Project	IEEE 802.16 Broadband Wireless Access Working Group < http://ieee802.org/16 >	
Title	BS IP address transmission using Cognitive Signaling and some editorials	
Date Submitted	2005-09-12	
Source(s)	Mariana Goldhamer Alvarion Tel Aviv, 21 HaBarzel Street Israel	Voice: +972 3 6456241 Fax: +972 3 645 6204 mailto:marianna.goldhammer@alvarion.com
Re:	Call for Contributions, IEEE 802.16h Task Group on License-Exempt Coexistence, IEEE 802.16h-05/014	
Abstract	Propose cognitive radio signaling for coexistence with ad-hoc 802.16 systems	
Purpose		
Notice	This document has been prepared to assist IEEE 802.16. It is offered as a basis for discussion and is not binding on the contributing individual(s) or organization(s). The material in this document is subject to change in form and content after further study. The contributor(s) reserve(s) the right to add, amend or withdraw material contained herein.

BS IP address transmission using Cognitive Signaling and general editorials

This paper has the changes underlined, versus the basic document. The last paragraph explains how the cognitive signaling, in association with the Coexistence Time slot, can allow the transmission of the Base St

Figure 1. Timing of Coexistence Time Slot

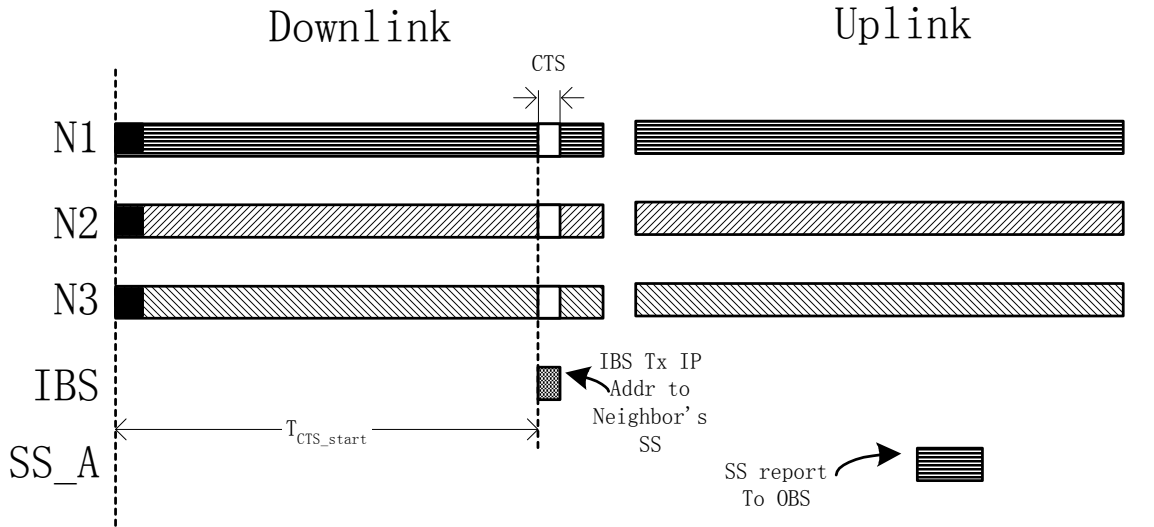
CTS must not be used for other purpose by all the BSs, so that it will be an interference free slot for the neighbor discovery purpose. Initializing BS (IBS) shall use this slot to broadcast its IP identifier, by sending a message and/or by cognitive radio signaling (l.b.d.), so that the neighbor operating BS (OBS) could find the new neighbor in IP network after the SS report the message. Then the IBS and OBS begin further negotiation for coexistence protocol.

The broadcasting procedure is unidirectional, only from the IBS to the SSs in IBS's-OBS's coverage, and the SSs shall report all the useful information to their OBSs they registered to. If the message will be forward correctly to the OBSs, the OBSs will then find the IBS in the IP network, and go further signaling using IP network.

Figure 3. Initialization procedures — BS

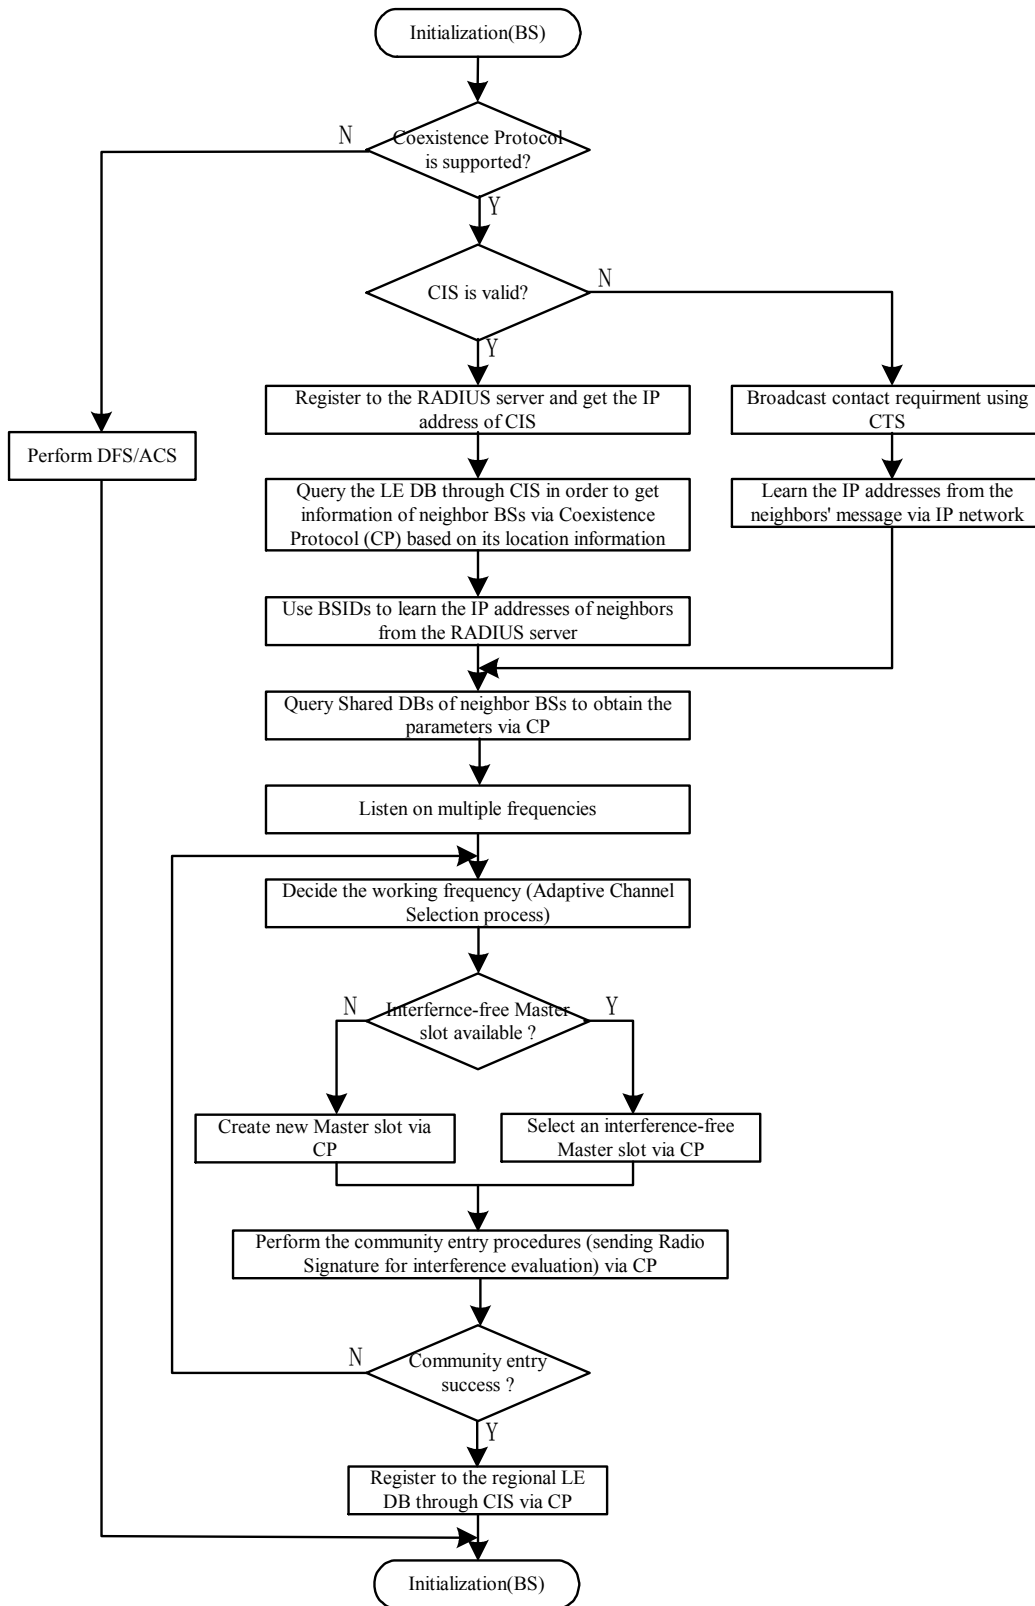
- Otherwise:*
 - *New BS uses the interference free slot to broadcast the message containing the contact request and/or the cognitive radio signal transmitting the IP address*

- *The SS in the common coverage will forward the information to its operating base station.*
 - *The operating neighbor BS send feedback information to the IBS, using the IP network*

- *The IBS learn the IP identifier of the neighbor BS By-from the message-message sent from-by the neighbor BS via IP network*
- *Build the local image of the relevant information in the community BS's, by copying the info in those BSs*
